**City Planning Commission Meeting**  
**Tuesday, March 10, 2015**

### **PRELIMINARY STAFF REPORT**

**To:** City Planning Commission  
**Zoning Docket:** 023/15

**Request:** This is a request for an amendment to Ordinance No. 25,555 MCS (Zoning Docket 084/13) to grant a Conditional Use to permit a fast food restaurant in a B-2 Neighborhood Business District and UC Urban Corridor District overlay and to consider setback waivers that were inadvertently omitted from Ordinance No. 25,555 MCS.

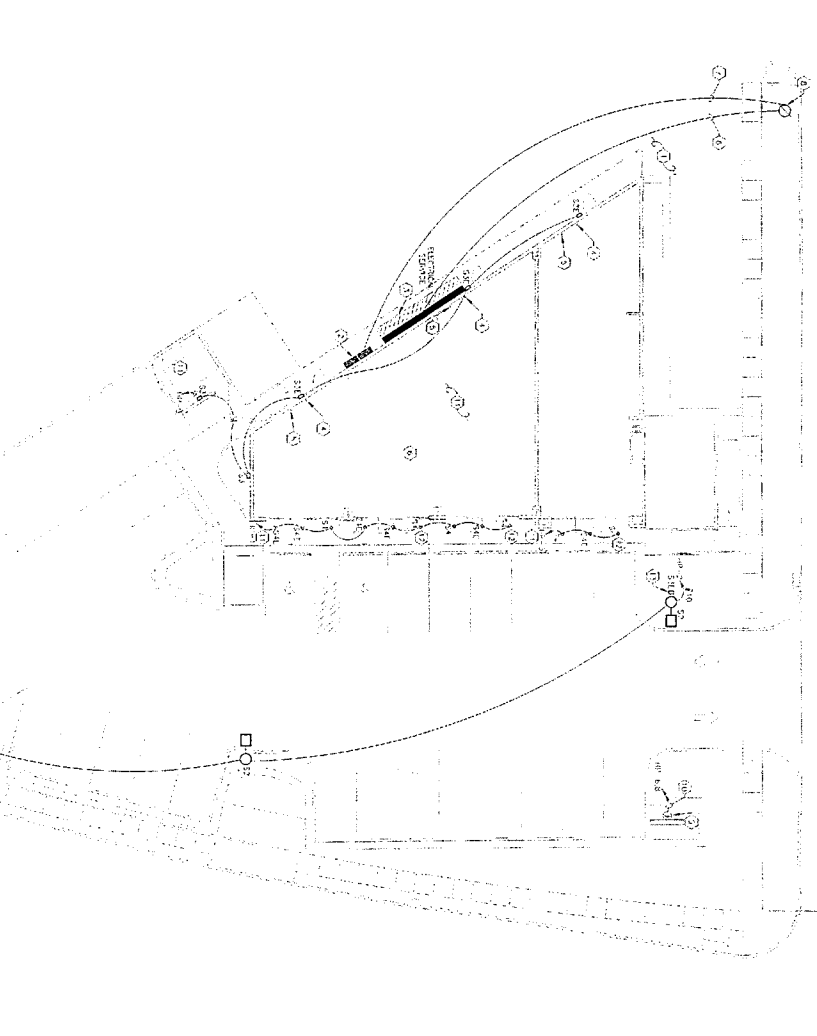
The submitted site plan indicates the location of a dumpster or trash containers. However, the method of screening is not indicated. If this conditional use is approved, the staff recommends the following:

The submitted site plans indicate the presence of landscaping onsite. The applicant proposes street trees along Holiday and General DeGaulle Drives. Staff believes additional trees between the proposed building/parking areas and the sidewalks would be appropriate. This area must be landscaped with a combination of trees, grass, and shrubs.

There is no direct pedestrian connection between the building and the public sidewalk system. Staff believes that this type of connection is necessary and should also be landscaped. No lighting is shown in the parking areas on the site plan. Any proposed lighting shall be approved by City Planning Commission staff.

Signage is shown on the elevations submitted and include (2) thirty one square foot signs, one on each frontage. The size and quantity of signage shown is appropriate based on the length and number of frontages. A detached sign is shown on the site plan but no details regarding its size and materials are indicated.

The site plan shows thirty-one off-street parking spaces, accessed via two curb cuts – one onto Holiday Drive and the other onto General DeGaulle Drive. Two of the spaces are designated as handicapped-accessible. The proposed parking spaces are eight feet six inches (8'6") in width and eighteen feet (18') in depth and two handicapped-accessible spaces are shown adjacent to the proposed building. To ensure compliance with the design standards in **Article 15, Section 15.2.5** of the Comprehensive Zoning Ordinance, staff recommends the following.

One (1) off-street loading space is required for the site<sup>3</sup>. The site plans does not show a designated loading space. It is anticipated that a fast food restaurant will

receive deliveries on a regular basis; therefore a loading space will be necessary. There is a dumpster enclosure which is blocked by the adjacent parking spaces. If this area is to be used as a loading space, then three (3) of the adjacent parking spaces must be removed to provide access to the loading space. There are enough parking spaces on the site to accommodate the requirements for an off-street loading space<sup>4</sup>. The loading space must meet the design standards in **Article 15, Section 15.3.4** of the Comprehensive Zoning Ordinance.

- The applicant shall provide revised site plans which indicate a loading space that meets the standards in **Article 15, Section 15.3.4** of the Comprehensive Zoning Ordinance. Access to the loading space shall not be obstructed by parking spaces or any other site elements.

- The revised site plans shall indicate an off-street loading area in compliance with **Article 10, Section 10.1.11.4c** of the Comprehensive Zoning Ordinance.

- The revised site plans shall include the location of house connections and the main water line, as well as a five foot (5') buffer within which no trees shall be planted.
